Project: IEEE P802.15 Working Group for Wireless Personal Area Networks (WPANs)

Submission Title: [LB50 Comment Resolution related to color frame]

Re: [Response to LB50 Comment]

LB50 Comment Resolution related to Color Frame

6.2.1.1.1 Semantics of the service primitive

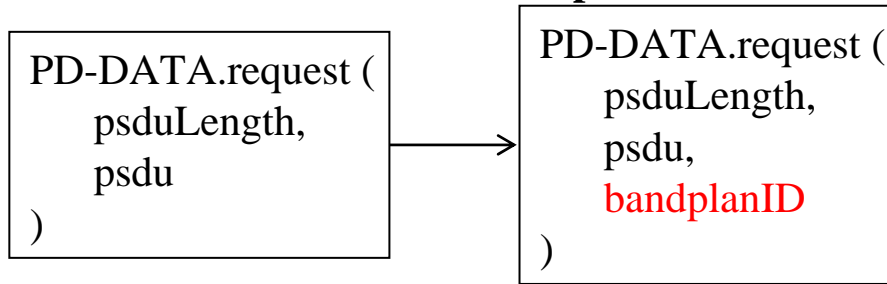
PLME Primitive Modification for Color Frame (CID 247)

- CID 247
 - We would like to suggest that the additional parameters for the use of color frame will be added to the clause 6.2.1.1 and the table 7 in the current D1 draft.
- Accept CID 247
 - We need the assignment of the color band for transmitting the corresponding psdu.

Clause 6.2.1.1.1 Modification (CID 247)

New Clause 7.1.17 (CID 635)

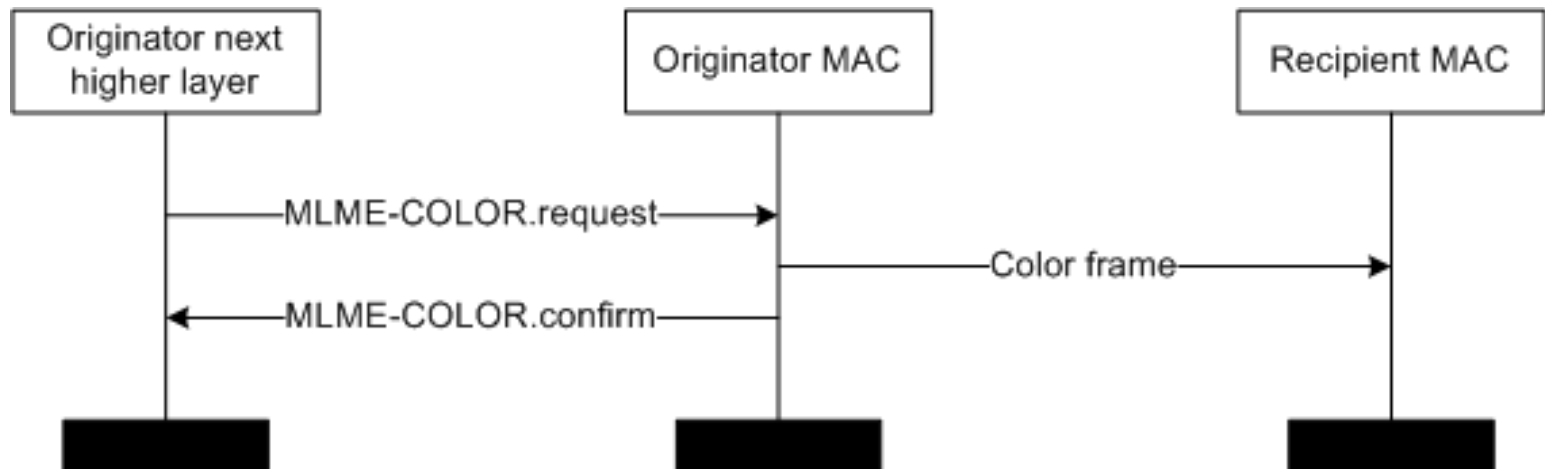
MLME Primitives for color frame (CID 635)

- CID 635
 - We would like to suggest that the new clause of 7.1.17 and its sub-clauses 7.1.17.1 and 7.1.17.2 for the use of color frame will be added to the current D1 draft.
- Accept,
 - We need new clause of 7.1.17 with 7.1.17.1 and 7.1.17.2 to transfer MLME primitive from upper layer to originator MAC
 - 7.1.17 Primitives for requesting color frame settings from DME
 - 7.1.17.1 MLME-COLOR.request
 - 7.1.17.1.1 Semantics of the service primitive
 - 7.1.17.1.2 When generated
 - 7.1.17.1.3 Effect on receipt
 - 7.1.17.2 MLME-COLOR.confirm
 - 7.1.17.2.1 Semantics of the service primitive
 - 7.1.17.2.2 When generated
 - 7.1.17.2.3 Effect on receipt

- 7.1.17 Primitives for requesting color frame settings from DME
 - MLME-SAP color primitives defines how to request color packet function from a DME.

Figure <XX>—Schematic view of the Color packet frame and the PHY packet

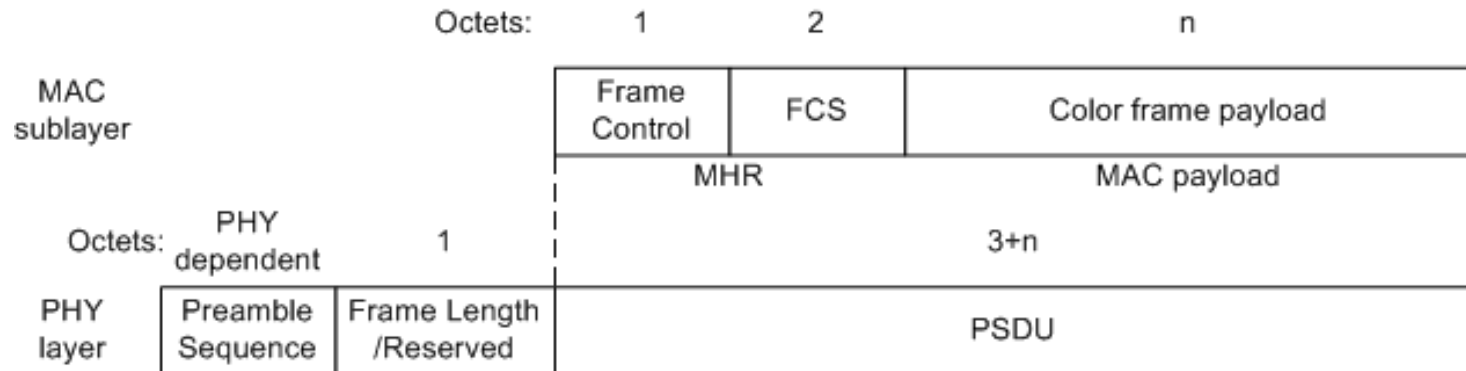
Color Frame Structure (CID 177)

- CID 177:
 - We would like to suggest that the new sub-clause of 5.6.4.6 for the use of color frame will be added to the clause 5.6.4 in the current D1 draft.
- Accept:
 - We need the new sub-clause, 5.6.4.6, for MAC frame which supports color packet function.

- 5.6.4.6 Color Frame
 - Figure <XX> shows the structure of the color frame, which originates from the MAC sublayer. MAC payload contains the color frame payload. MAC payload is prefixed with an MHR. The MHR contains the MAC Frame Control field and a 16-bit FCS. The MHR and MAC payload together form the color frame, (i.e., MPDU).

- The MPDU is then passed to the PHY as the PSDU, which becomes the PHY payload. The PHY payload is prefixed with an SHR, containing the Preamble Sequence field, and a PHR containing the length of the PHY payload in octets. The preamble sequence enables the receiver to achieve symbol synchronization. The SHR, PHR, and PHY payload together form the PHY packet, (i.e., PPDU).
- The color frame is used for the color packet function.
- An user can perceive intuitively some information (such as the current step of communication procedure, the data transmission quality, the transferred file size or remained file size).

Figure <XX> -MAC Color frame format

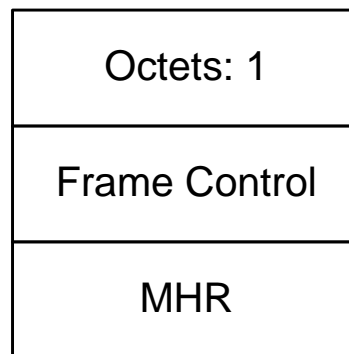
Color Frame Control Field (CID 660)

- CID 660
 - We would like to suggest that the new clause of 7.2.2.4 and its sub-clause 7.2.2.4.1 for the use of color frame will be added to the current D1 draft.
- Accept
 - New clause of 7.2.2.4 with 7.2.2.4.1 are needed to define the control field for color frame

- 7.2.2.4 Color Frame Format
 - The MAC color frame shall be formatted as illustrated in Figure <XX>.
 - The MHR for a color packet frame shall contain the Frame Control field.

- In the Frame Control field, the Frame Type subfield shall contain the value that indicates a color frame, as shown in Figure <XX>.
- The Color Packet Indicator field(CPI) shall contain whether this frame include color frame payload.
- The Peer Device Information Indicator(PDDI) field shall contain the information for transferring to the peer device such as channel quality.

Other Comment Resolution related to Color Frame CIDs

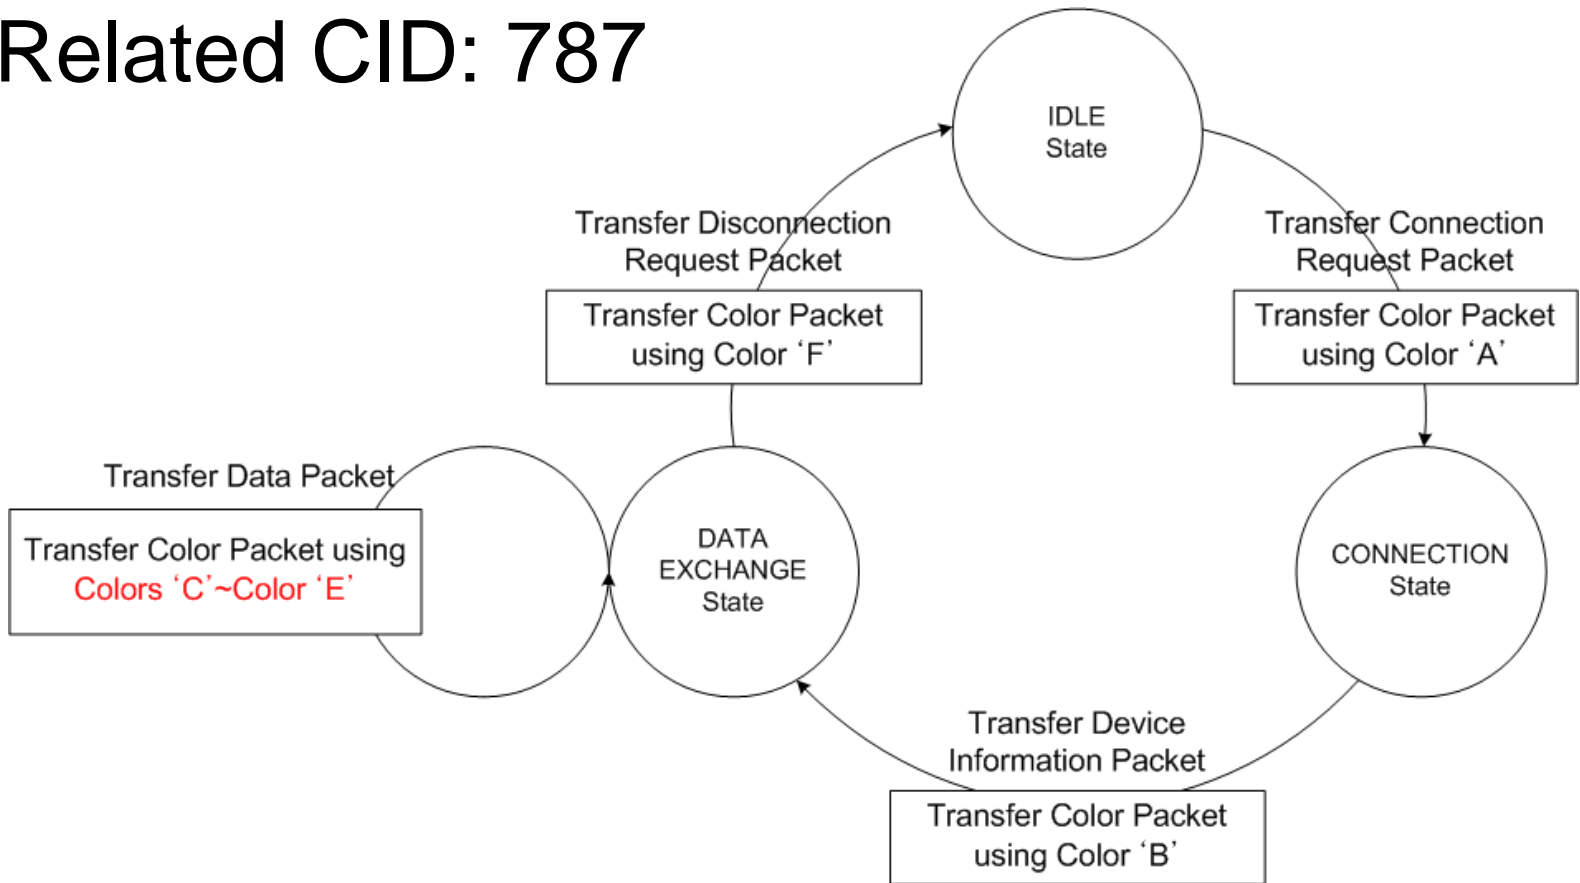
7	785	David Cyp	7	7.6.10	213	33	Table XX ??	Try Table 88
8	786	Clint Chap	7	7.6.10	213	24	(TB) Not sure the sub-title meaning, especially, supplemental / information,	remove "information"
9	787	David Cyp	7	7.6.10	217	15	Figure 123 is supposed to be used in conjunction with Figures 119, 120, 121,	Add "using color 'C' to Transfer Data box replacing various colors.
10	788	David Cyp	7	7.6.10	217	25	"slide" really?	Replace "This slide ..." with "Figure 123 ..."
11	789	David Cyp	7	7.6.10	217	53	Figure 123 is specific to the example, while Figure 124 is general, lacking	Rewrite sentence leaving out Figure 123 and any reference to the
12	790	R. Roberts	7.6.10		217	25	modify sentence at line 25	Instead of saying "This slide" we ought to reference the figure number.
13	791	R. Roberts	7.6.10		217	25	reference to Previous Basic Communication Procedures.	What is meant by "Previous Basic Communications Procedures"?

- CID 785
 - We changed ‘Table XX’ to ‘Table 88’
- CID 786
 - We removed ‘information’
- CID 787
 - Change Figure
 - We changed various color to Color ‘C’~ Color ‘E’
- CID 788, 790
 - We changed ‘This slide’ to ‘Figure 123’
- CID 789
 - The comment seems not to be clear, so we reject this comment.

Other Comment Resolution related to 5 CIDs

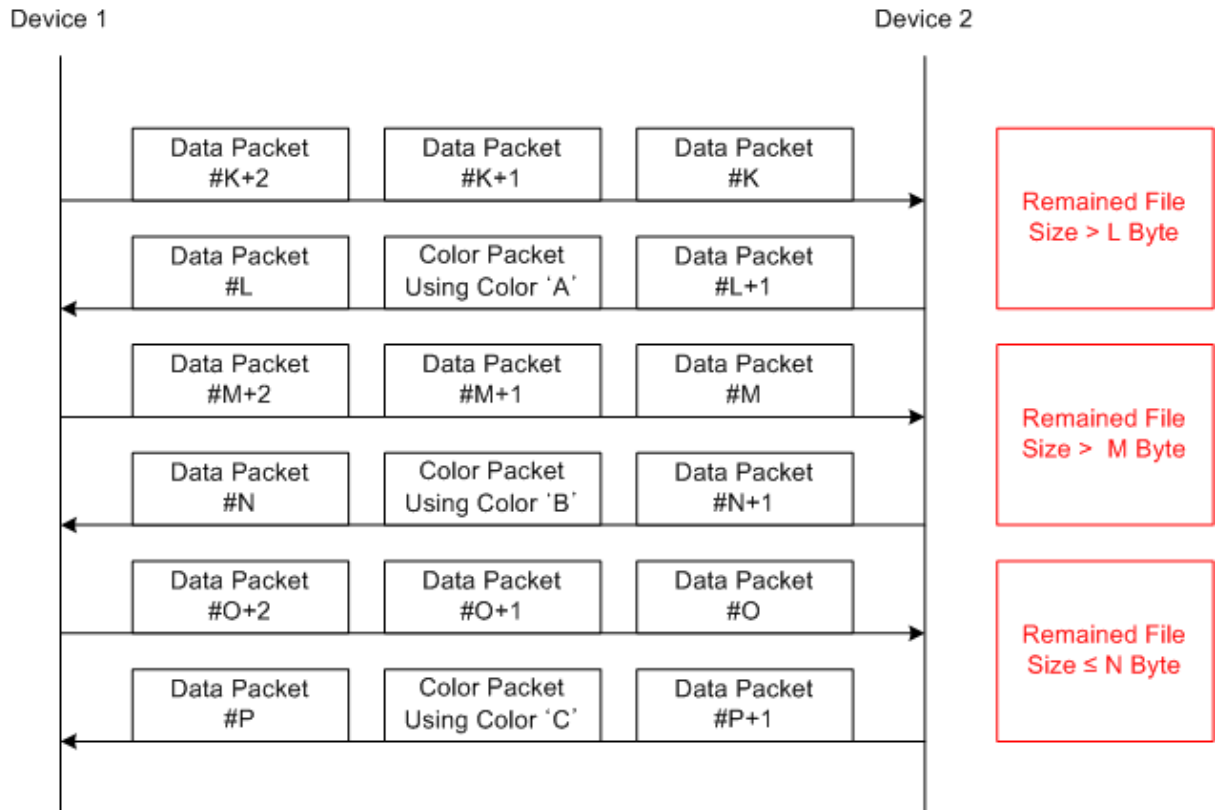
14	792	Clint Chap	7	7.6.10	218	8	(TB) No definition or explanation LV in Fig.125	define or explain what the LV is.
15	793	Clint Chap	7	7.6.10	218	8	(TB) Not sure the right side boxes is place in right.	Box replace on the right side next to device 2. if the box shows the
16	794	R. Roberts	7.6.10	Figure	218		In figure 125 reference is made LV1 byte, LV2 byte and LV3 byte.	What does LV mean and should it be added to the acronym list?
17	795	David Cyp	7	7.6.10	219	51	Table 89 is marked as an example, yet the text states that the user can	Unknown
18	796	Clint Chap	7	7.6.10	219	30-31	(TB) Need more explanation about 125, Which device is going to use the	Insert the below sentence or more explanation
19	797	Clint Chap	7	7.6.10	219	31-32	(TB) Need more explanation about 125, how this color packet works?	Insert the below sentence or more explanation
20	798	David Cyp	7	7.6.10.	220	1	2009 IEEE Standards Style Manual 11.1 is not being followed.	remove heading 7.6.10.1, since there is no other subclause.

- CID 791
 - We changed ‘Previous Basic Communications Procedures’ to ‘MAC State Transition Procedures’
- CID 792, 793, 794, 796, 797
 - Instead of LV1, LV2, LV3, we changed L, M, N
 - We changed the Figure
 - We explained the Figure
- CID 795
 - This table is an example for information.
 - So we reject this comment.

Accept : CIDs 792, 793, 794, 796, 797

- By the insertion and modification of PLME primitives and MLME primitives for color frame
 - CID 177, 247, 635, 645, 660, 798, 799, 800 are resolved.
- Comment Resolution by the modification of Figure 125
 - CIDs 792, 793, 794, 796, 797 are resolved.
- Other CIDs are resolved by the suggested remedy
 - CIDs 785, 786, 787, 788, 790, 791 are resolved.
- CIDs 789 and 795 are rejected.
